Architect's Supplemental Instructions

Architect's ASI No: 063

Project:
Webster University
Interdisciplinary Science
Building

Date Issued: 04/21/17

Drawing Title:

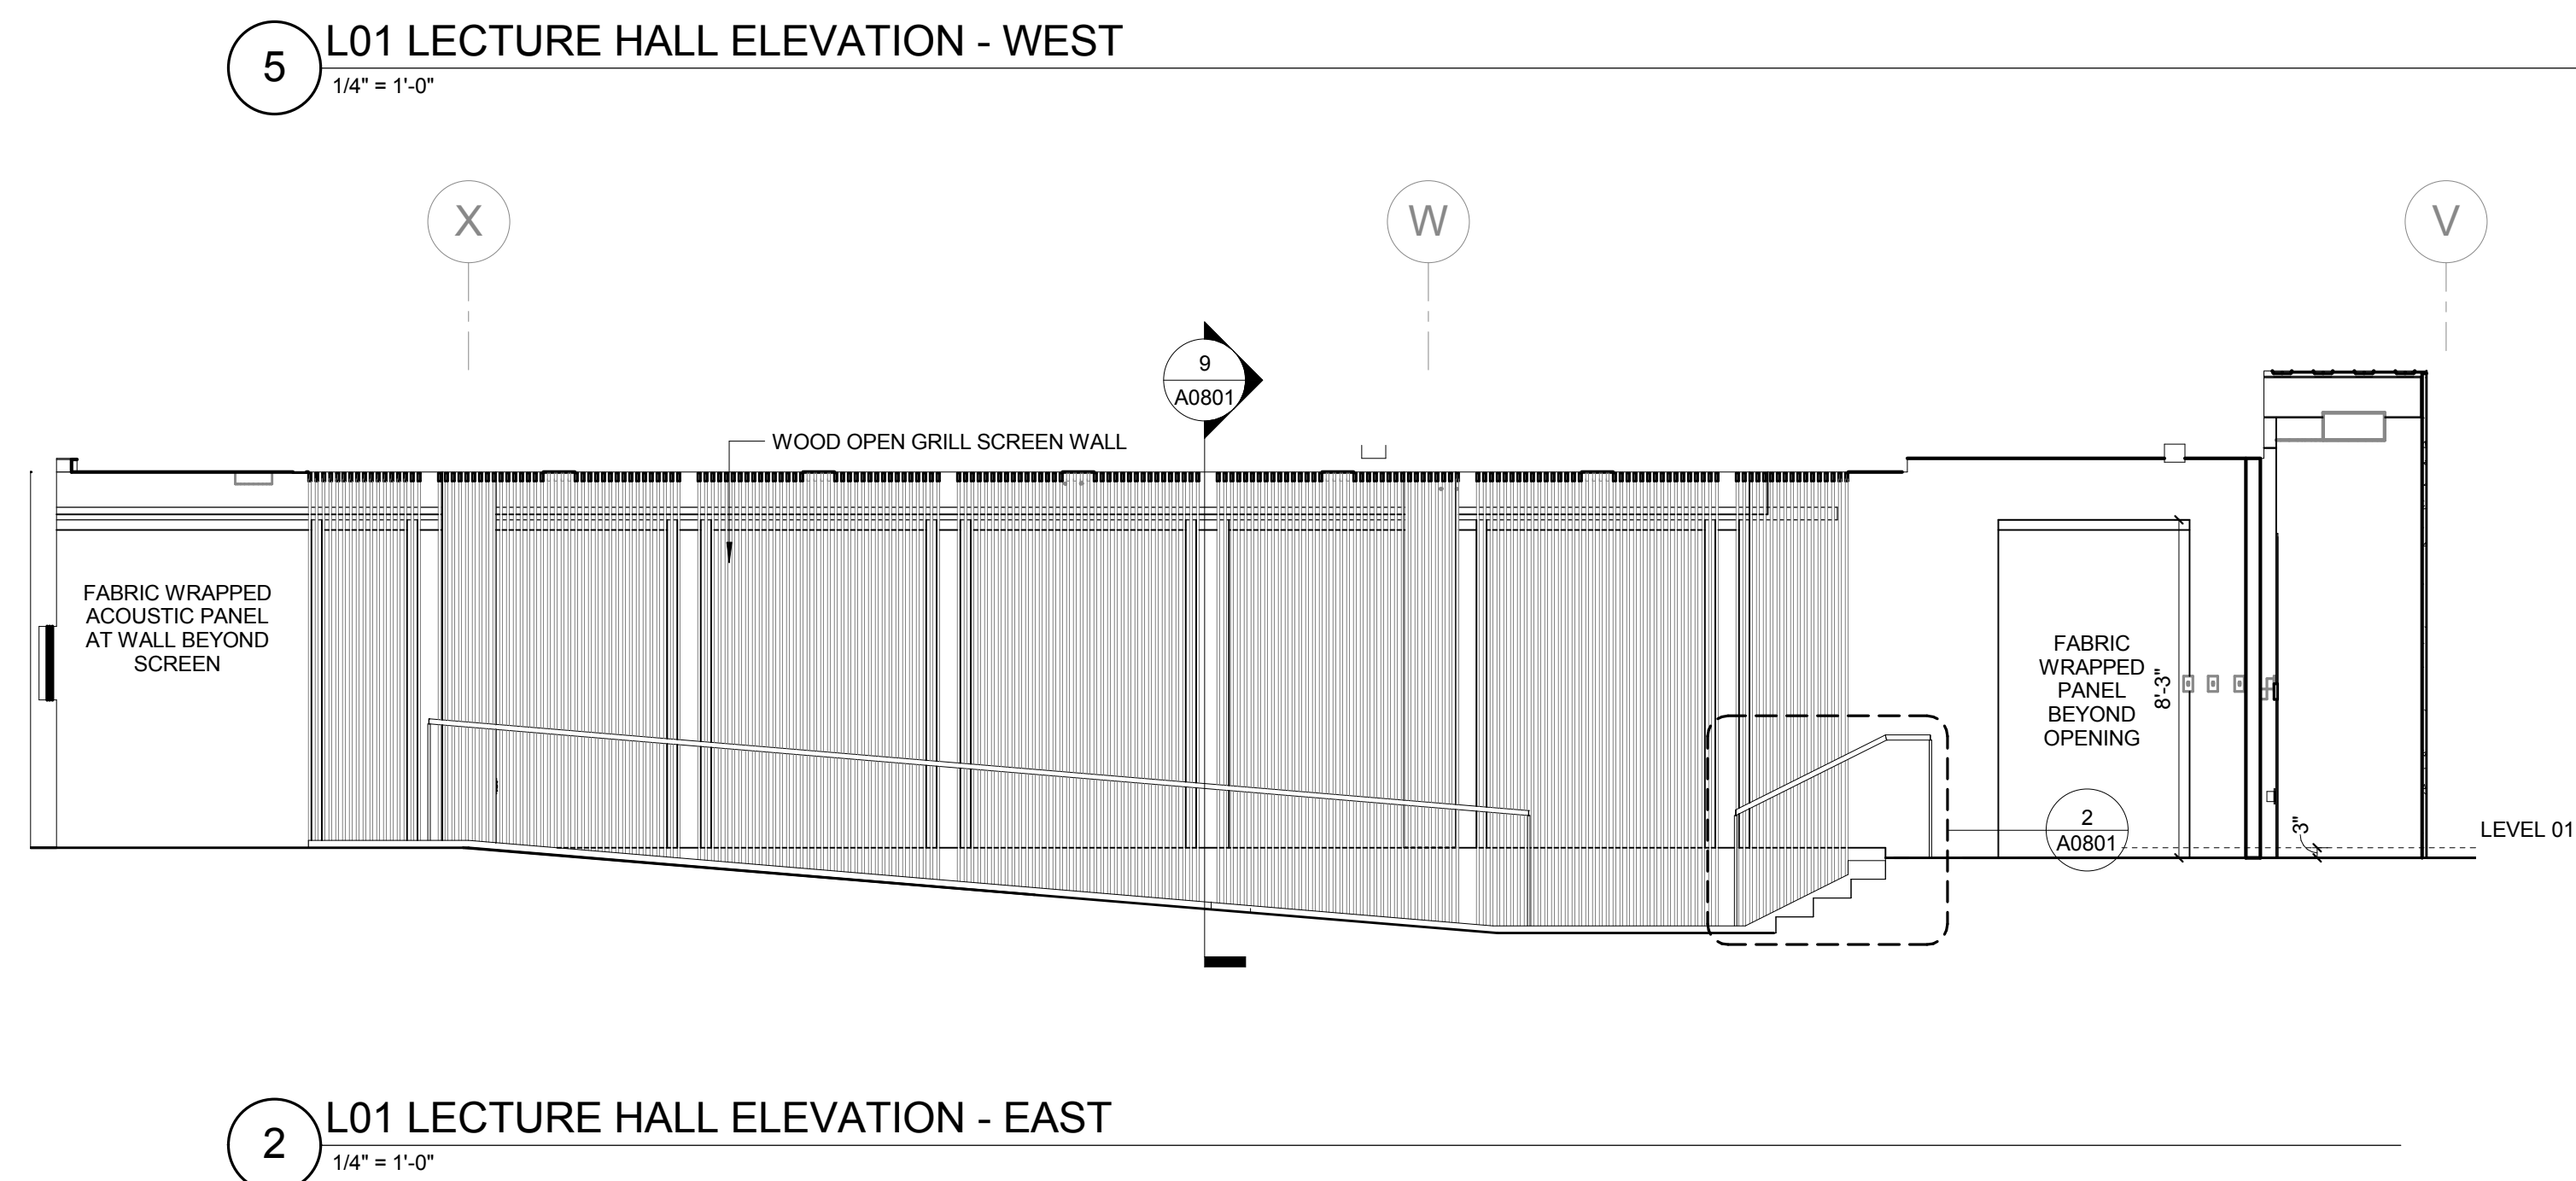
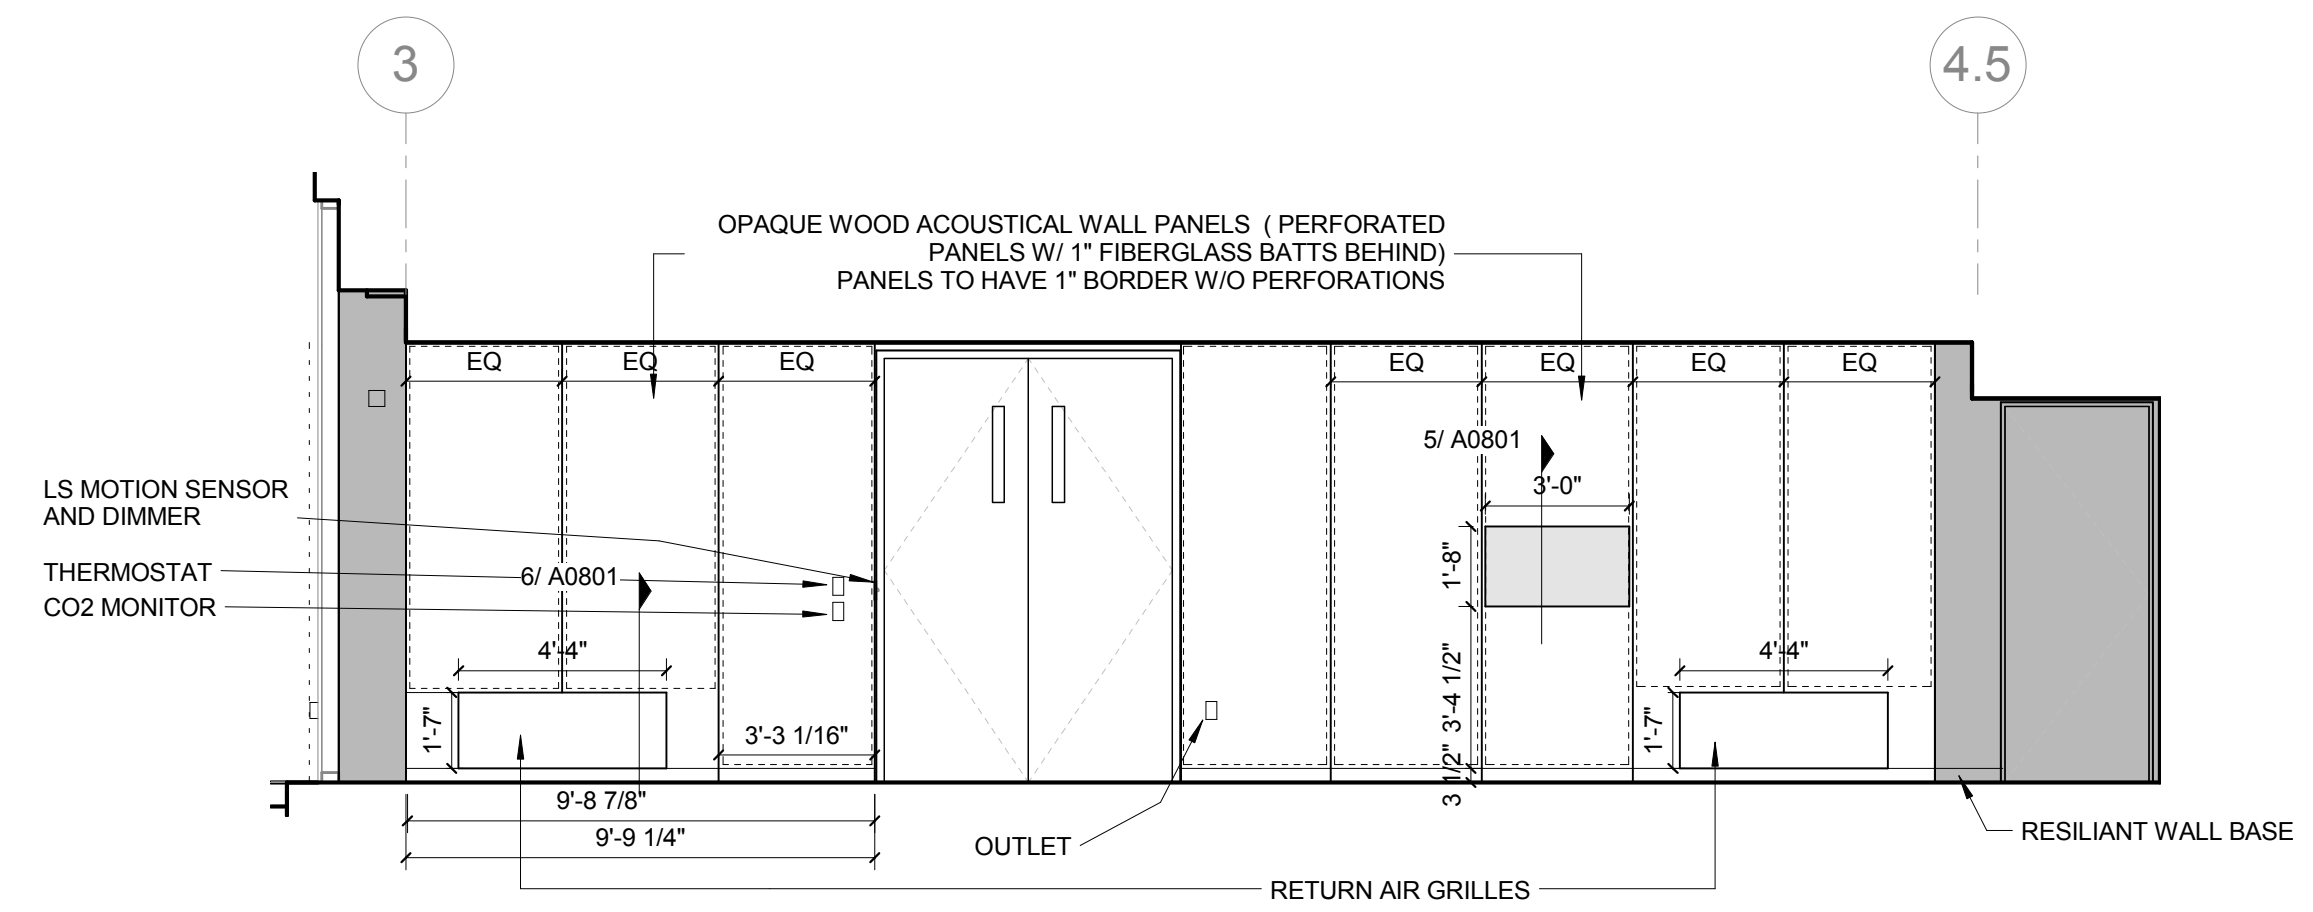
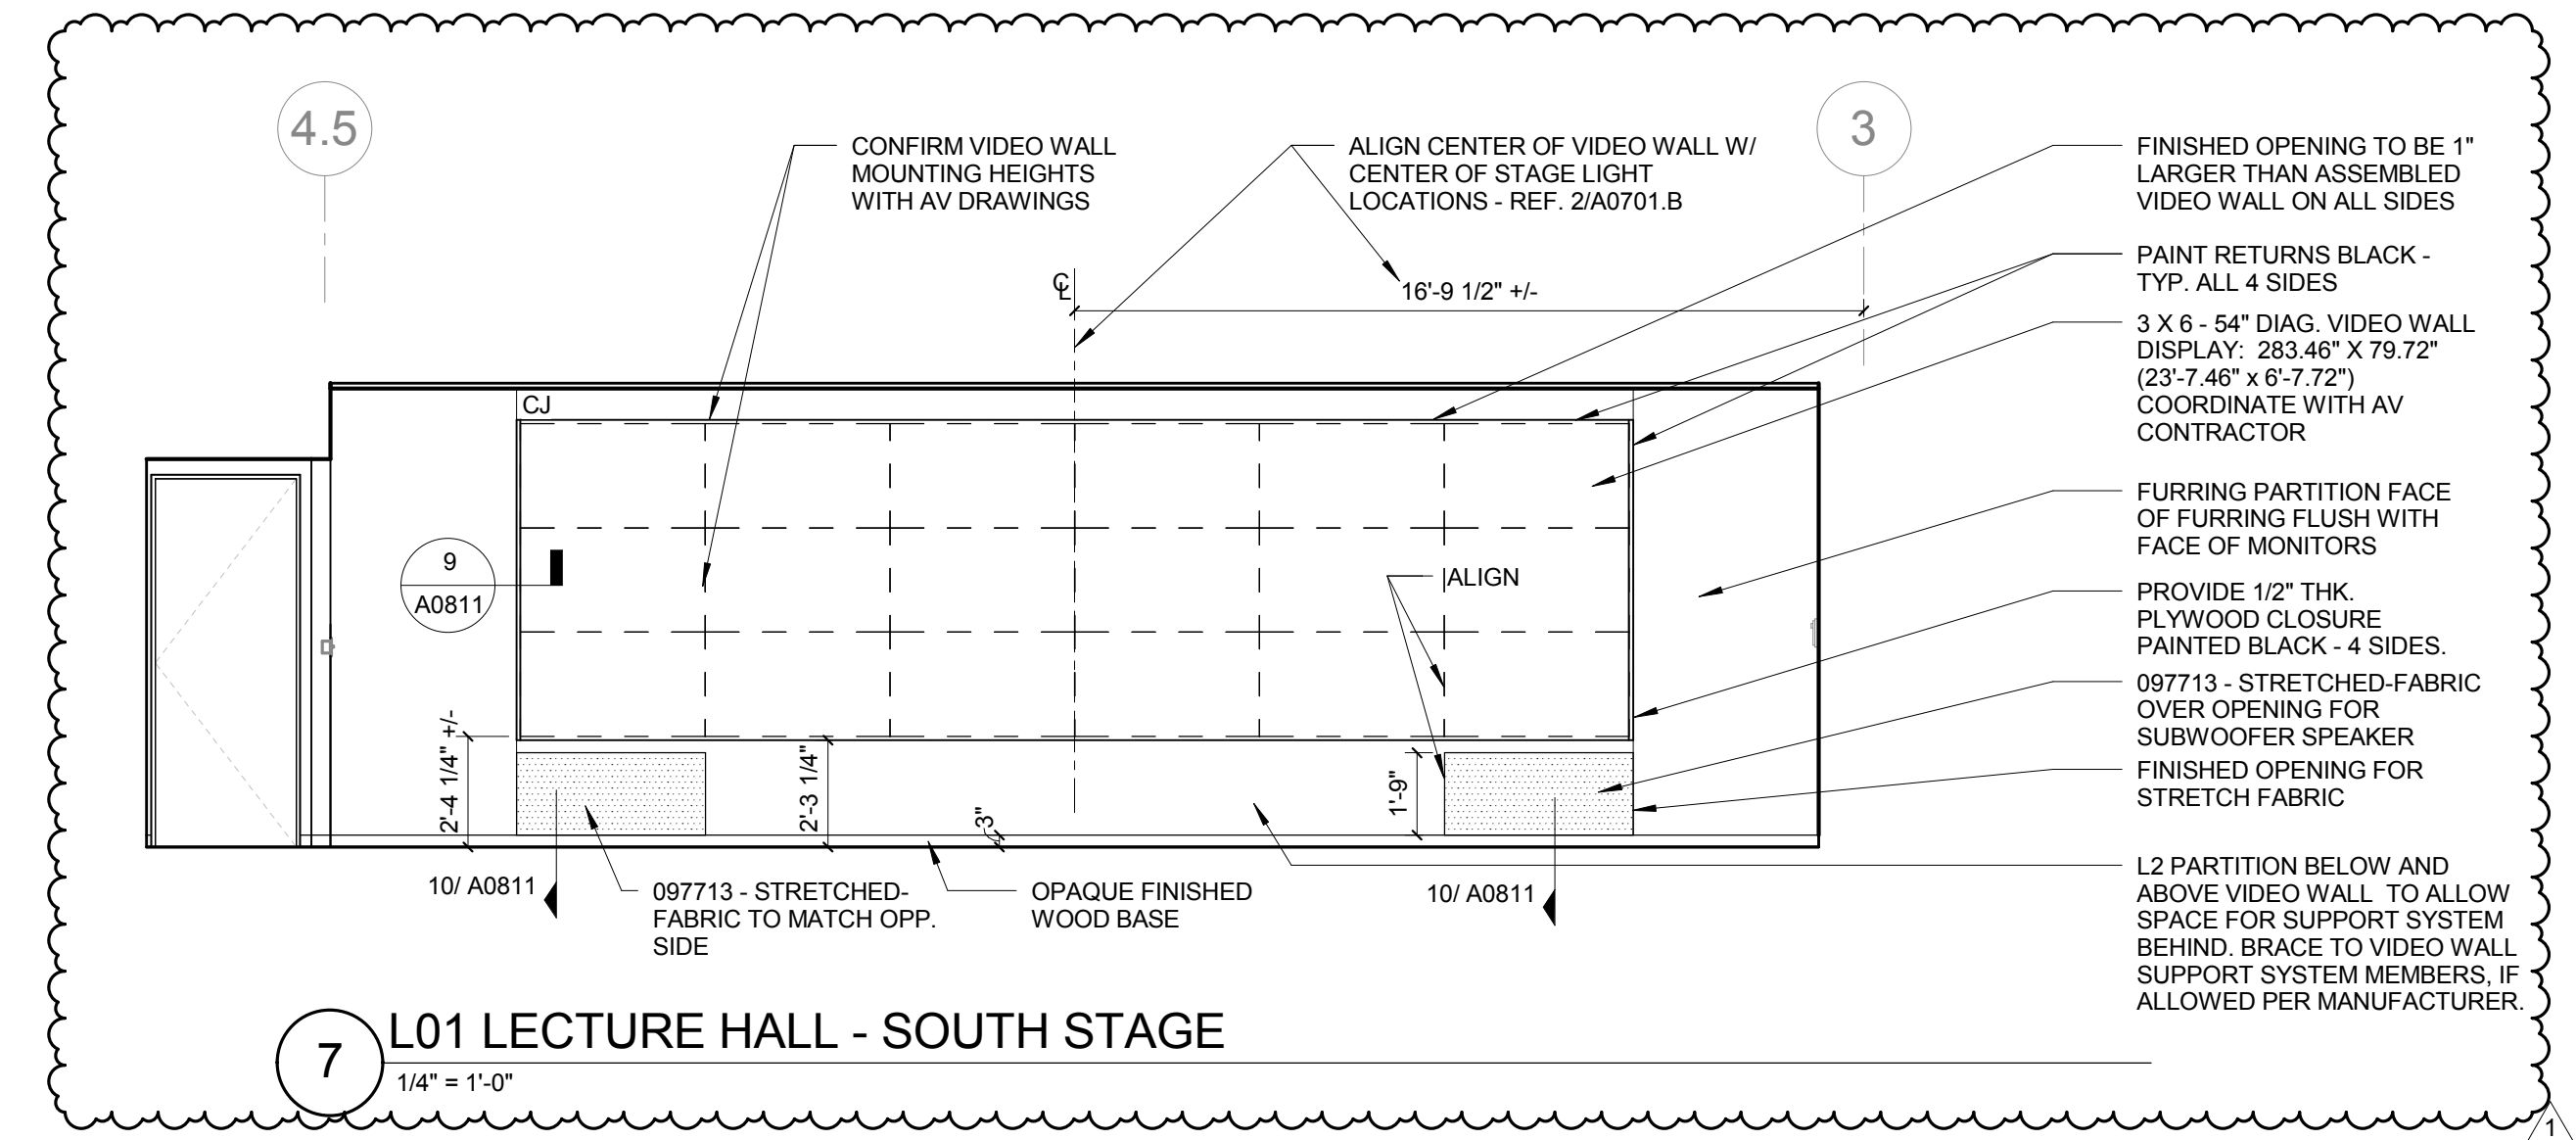
- Revised partition layout and details to accommodate revised Video wall selection per AV drawings.
- Added ceiling mounted curtain tracks in room 131 HEALTH ASSESSMENT LAB.
